DEVELOPMENT ADMINISTRATION BOARD AGENDA REPORT ITEM #1

DATE: October 10, 2024
TO: Development Administration Board
FROM: Rob Patterson, City Attorney / Planning & Zoning Administrator
SUBJECT: **Final Plat Approval:** Ridgeview Plat L
TYPE: **LAND USE (ADMINISTRATIVE)**

RIDGEVIEW POD B PLAT L

ATTACHMENT 6

RIDGEVIEW POD B PLAT L
HIGHLAND CITY, UTAH COUNTY, UTAH
SECTION PLAN

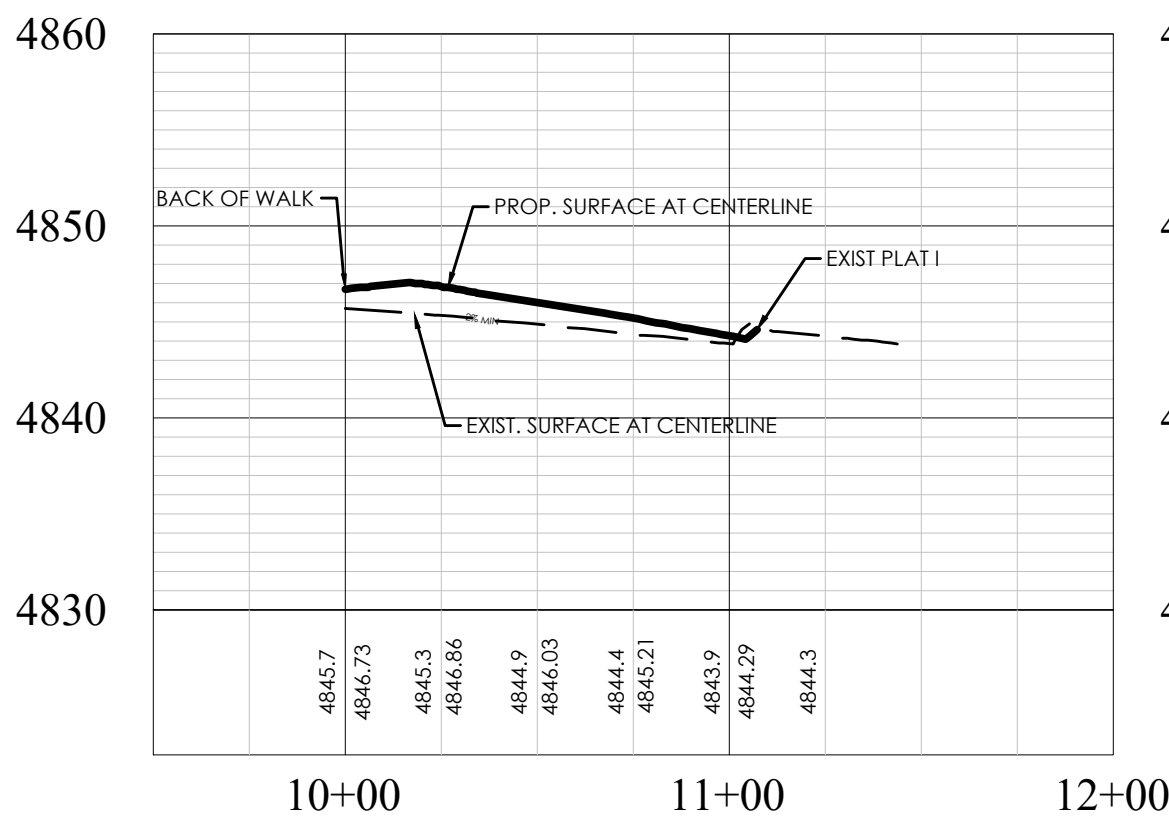
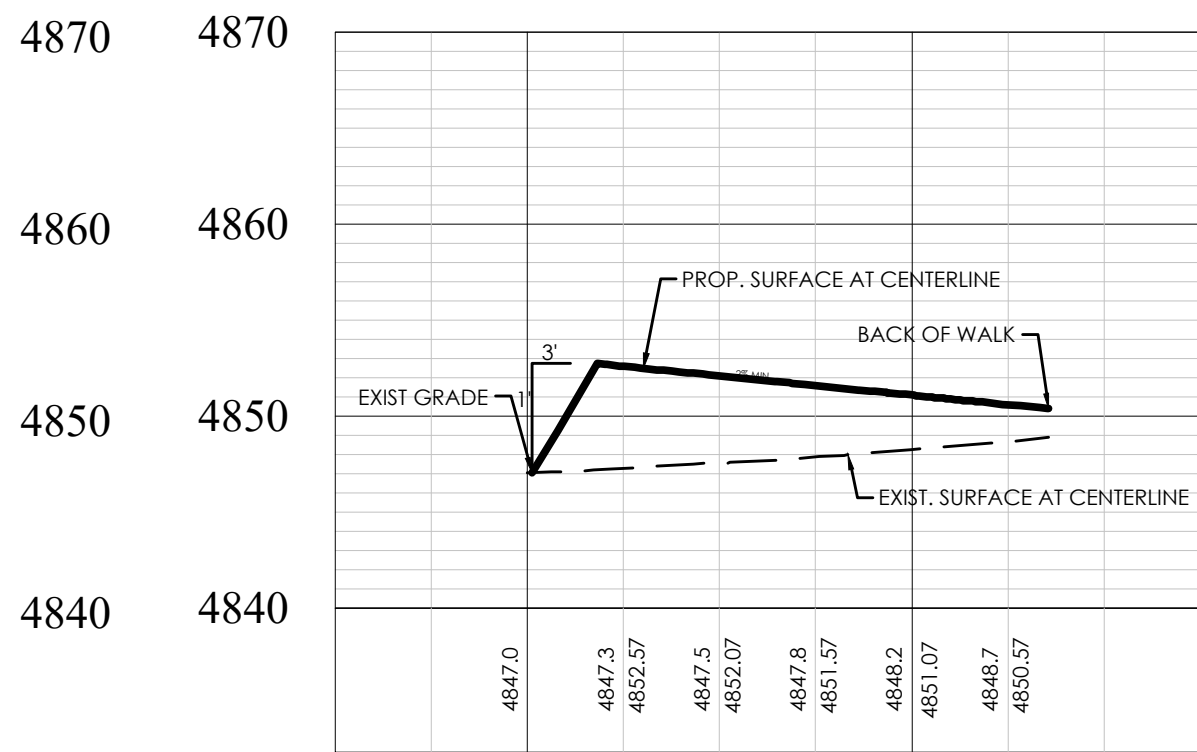
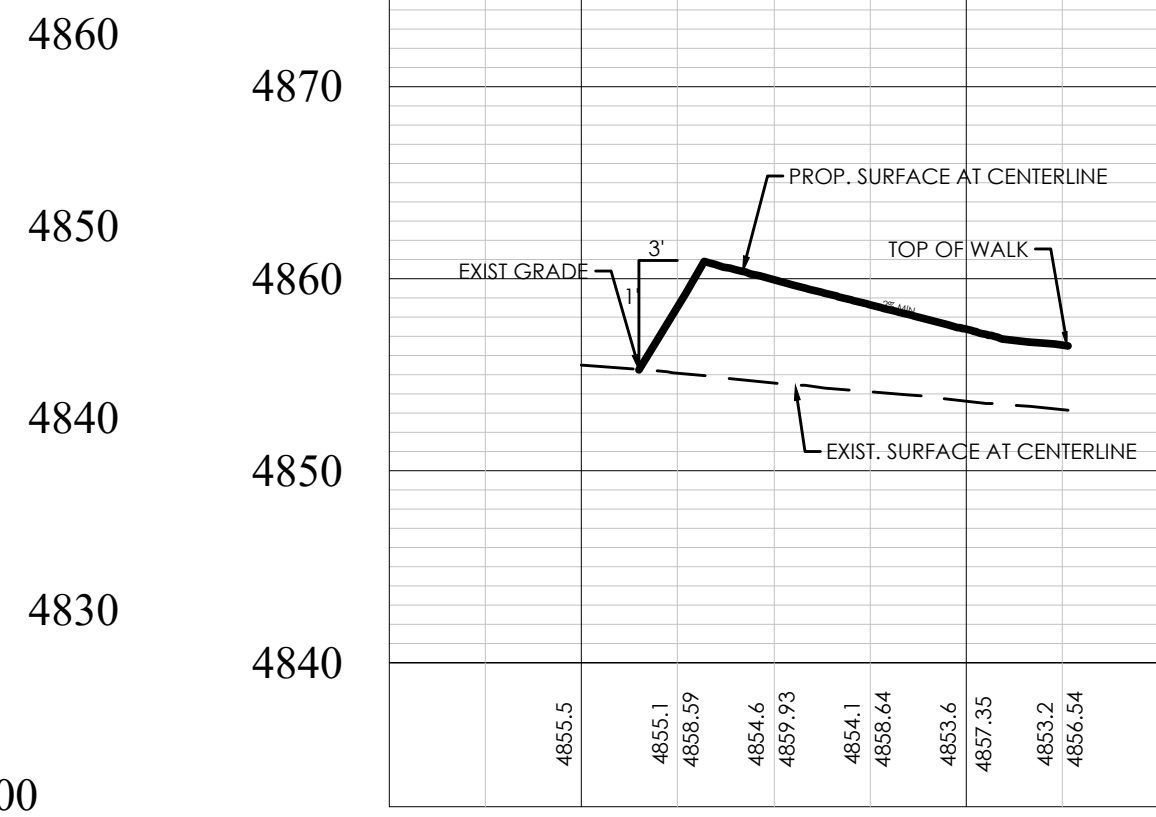
1. Temporary Turnaround: Symbol for 'No Parking Signs' added to sheet, but no details/spec/instructions provided. Provide enough detailed information so item can be approved by staff and built by contractor.
2. Crosswalk: Crosswalk shown, but no details/spec/instructions provided. Provide enough detailed information so item can be approved by staff and built by contractor.
3. Sumps: Storm drain report, Sheets C4-C4.2 (Grading and Drainage Plan):
APPLICANT RESPONSE IN GREEN (review comment #22):

- b. Revise the detail so it is readable, legible, and show what is to be built. Also, the calculations provided in the appendix of the drainage report for the rear yard sump do not share the same dimensions as the detail. Please revise.

-New response: The sump detail in the drainage report was revised and does match the detail included in the plan set.

-New response: There are two different sumps which are street sump and rear lot sumps. We added both to the drainage report and the rear lot sumps are shown on sheet C4.3.

GREEN ASH LANE PLAN

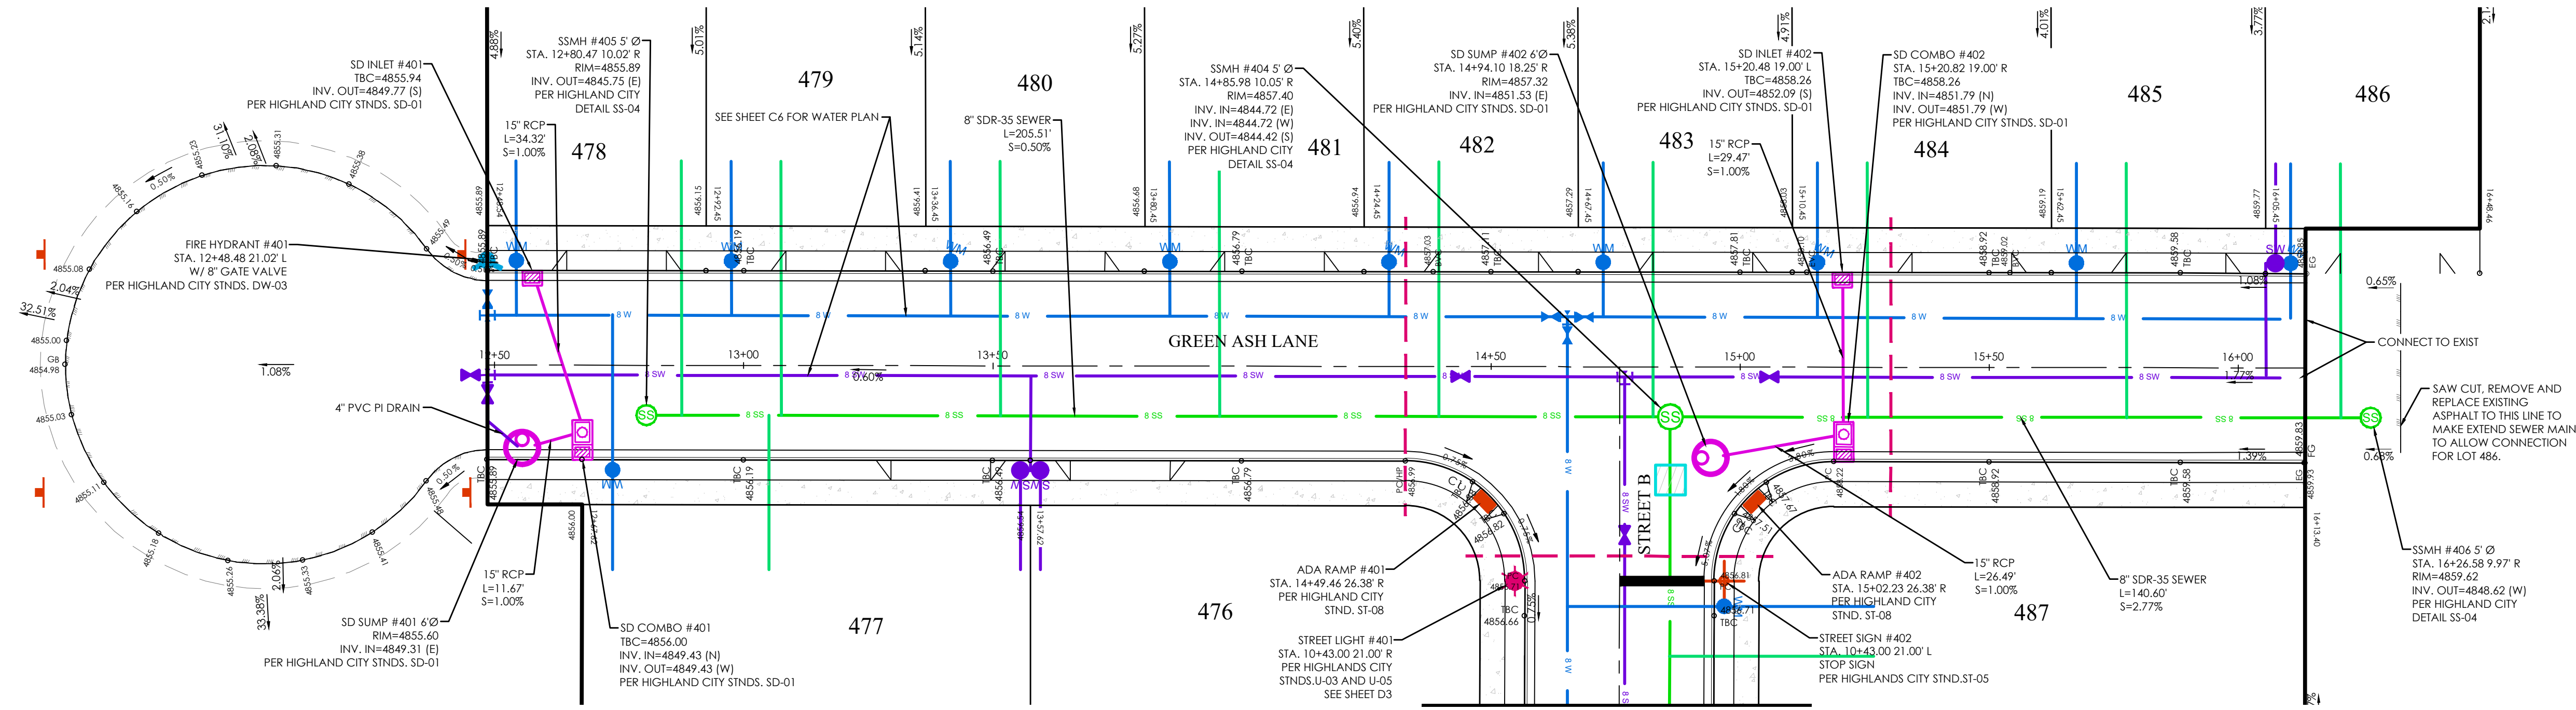
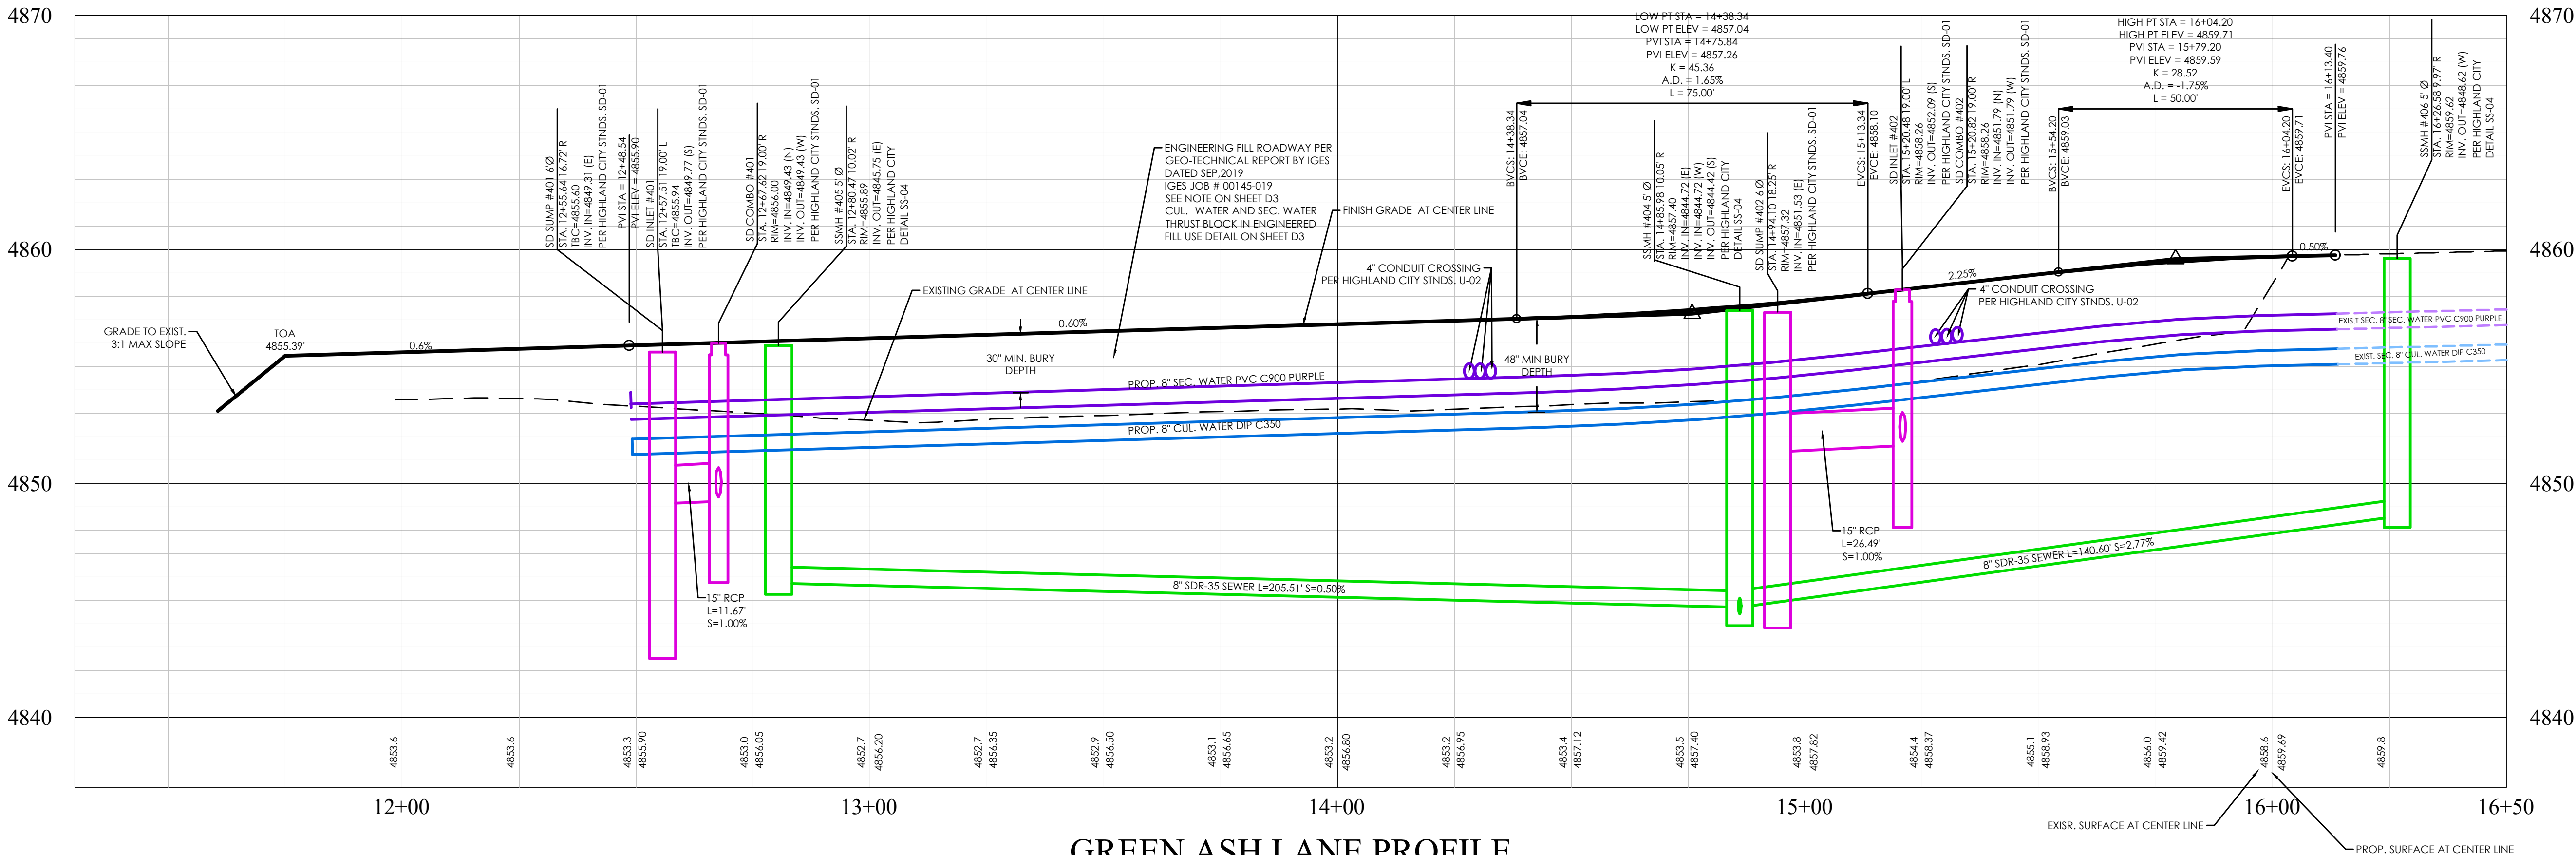
4. Green Ash Lane/Street B, Sheets PP01, PP02, PP03: Remove "Street B" from match lines and from plan views.
5. Crimson Oak Lane, Street Monument, Sheet PP04: Please provide reasoning for the location of the street monument. It does not mark the intersection of the two streets.
